Denver Union Station Redevelopment

Public Presentation on Transit Architecture | July 16, 2009

Public Comment on Transit Architecture

Train Hall Architectural Design

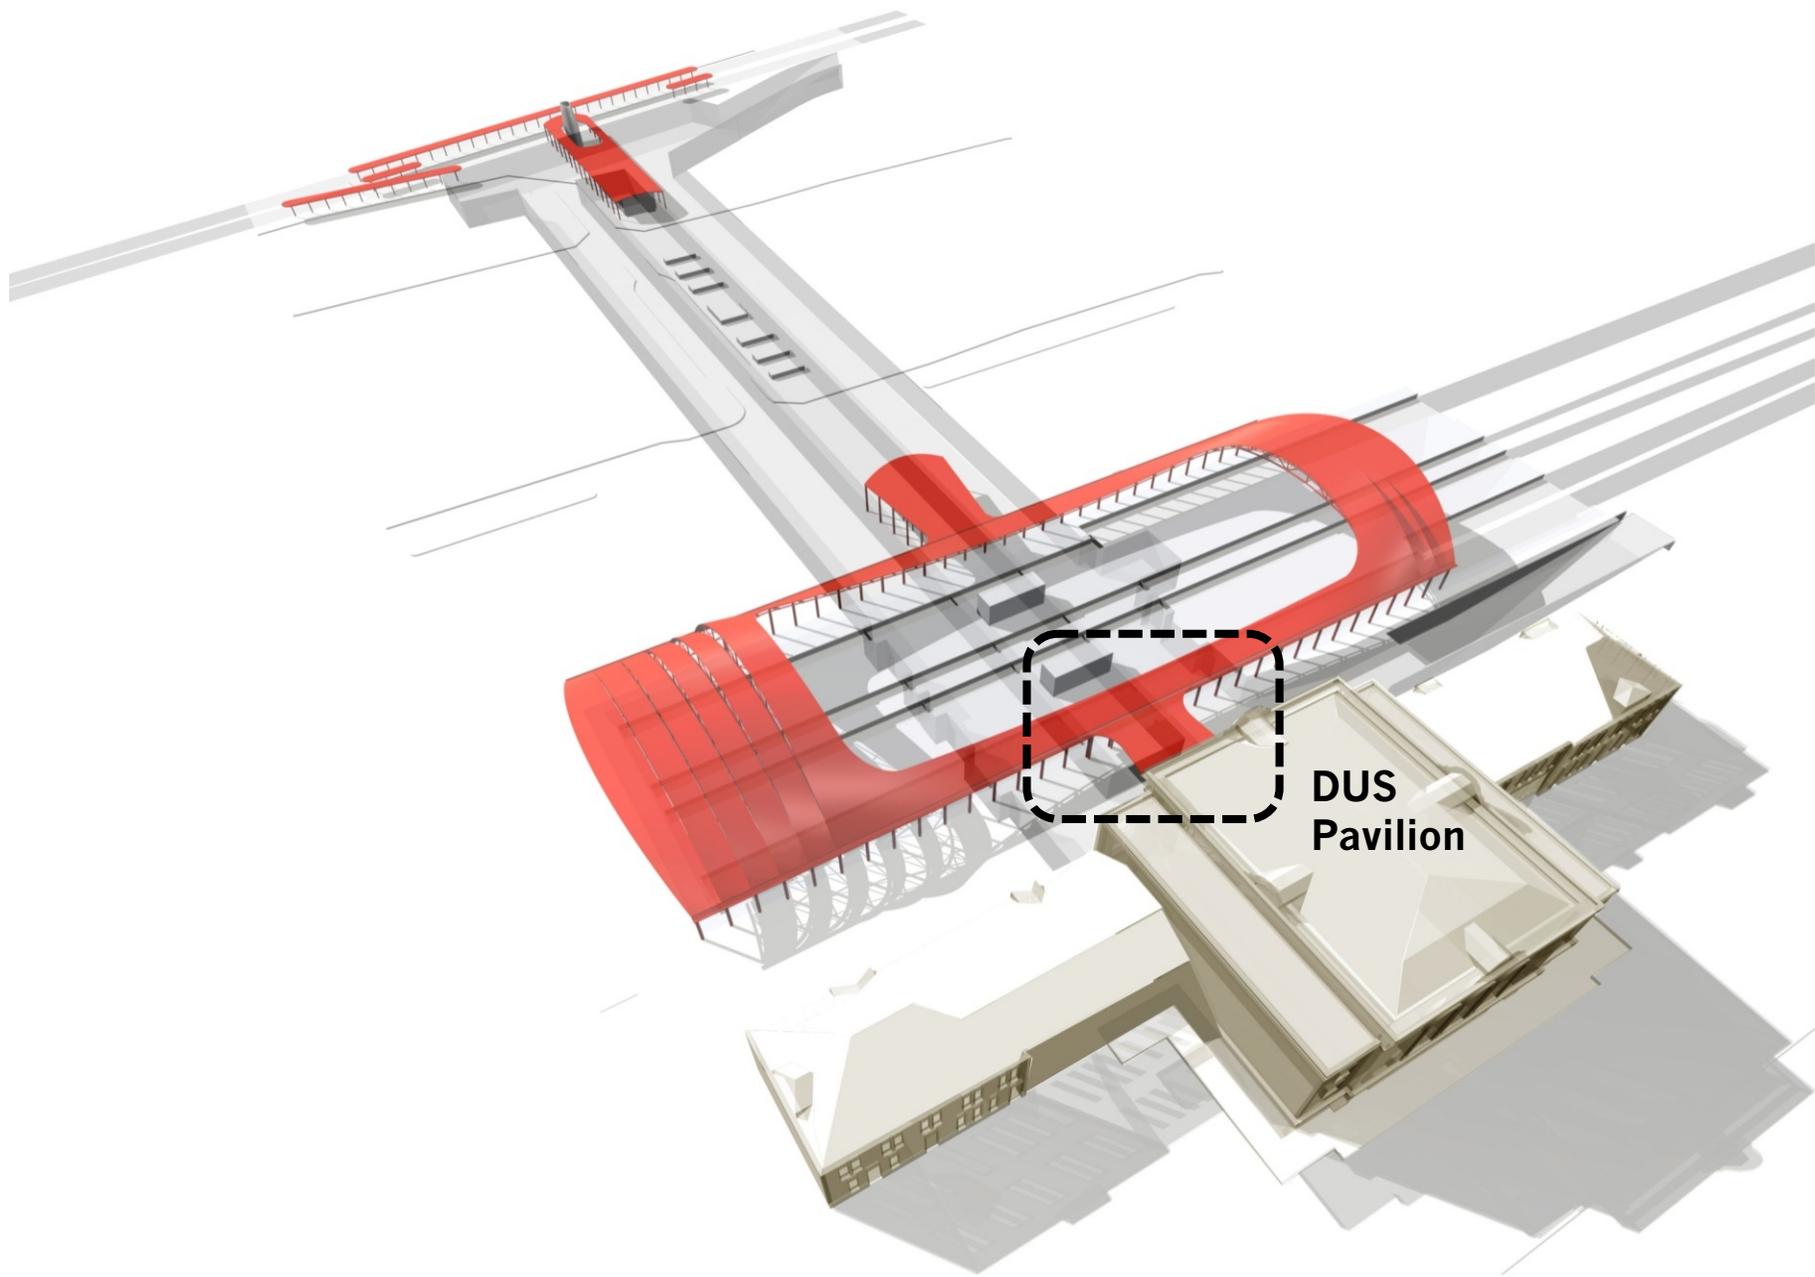
- Most walls (of private development) surrounding train hall are blank walls. This is important problem. How to create pedestrian friendly facades here needs to be looked at carefully.
- It is crucial that the passageway from 16th Street through the A Block building have a real presence on 16th Street. This building functions as a headhouse to the CRT.

- The DUS Urban Design Standards & Guidelines address considerations for the future adjacent mixed-use development.
- DUS wayfinding design will address the concern about intuitive circulation.
